AVR64EA28/32/48 Silicon Errata and Data Sheet Clarifications

AVR64EA28/32/48

3. Data Sheet Clarifications

Figure 35-1. $\overline{\text{POR}}$ and $\overline{\text{POR}}$ Re-Arm with Slow Rising V_{DD}

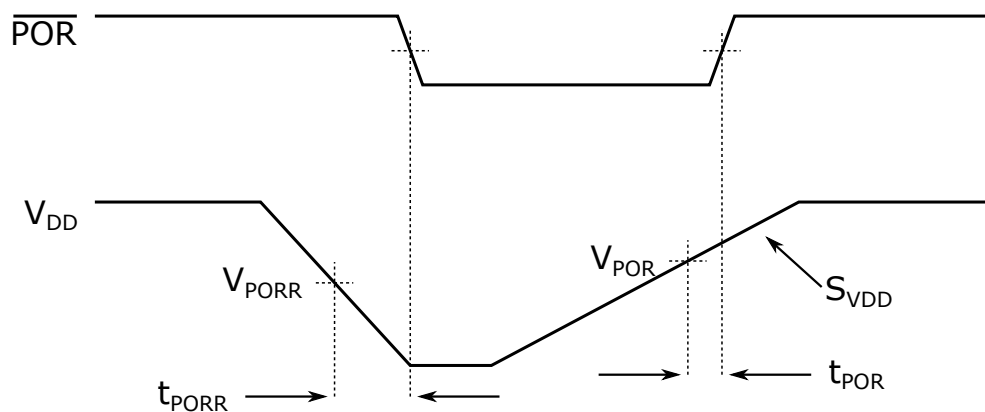
3.3 Electrical Characteristics - Supply Voltage

Some clarifications have been made to the *Supply Voltage* table.

1. During Chip Erase, the Brown-out Detector (BOD) configured with BODLEVEL0 is forced ON. The erase attempt will fail if the supply voltage V_{DD} is below V_{BOD} for BODLEVEL0.
2. Operation is ensured down to 1.8V or BOD triggering level V_{BOD} when BOD is active.
3. This is the limit to which V_{DD} can be lowered in sleep mode without losing RAM data.
4. Refer to 35.11. RSTCTRL and BOD for BOD trip point information.
5. Refer to Figure 35-1.
6. For design guidance only and not tested in production.
